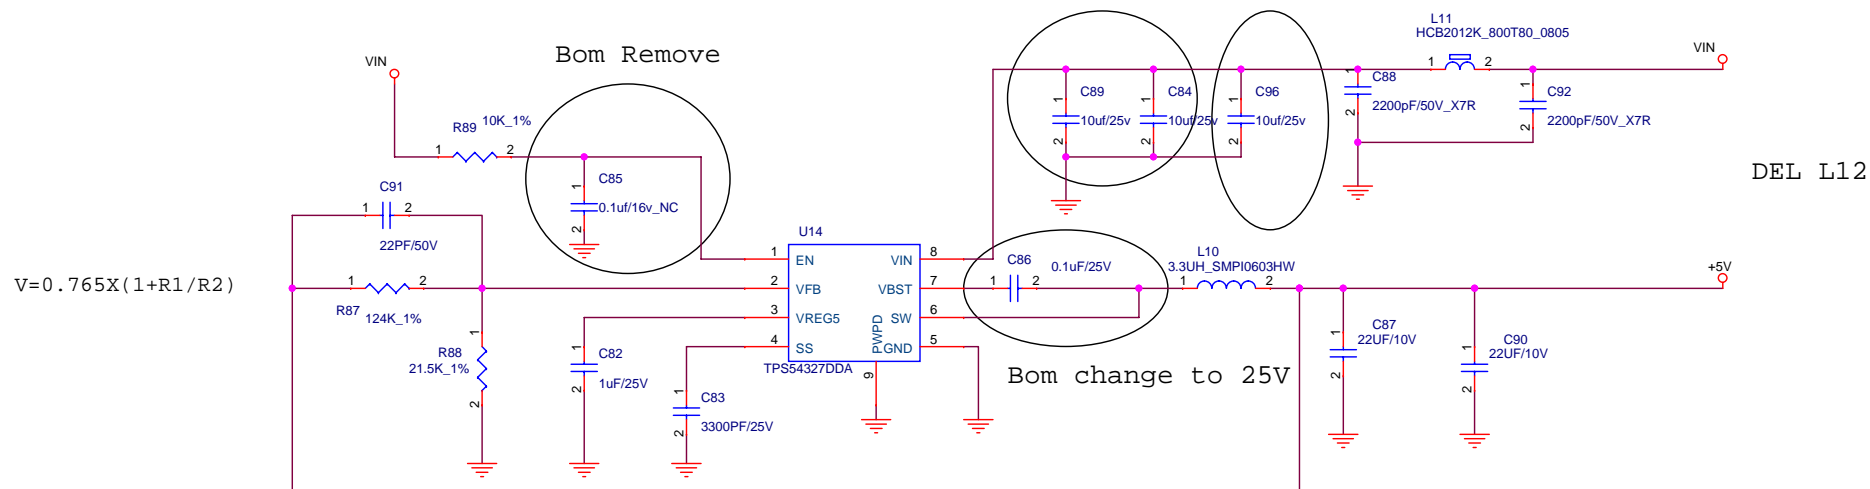
Change Package to 1206 and add 10UF/25V
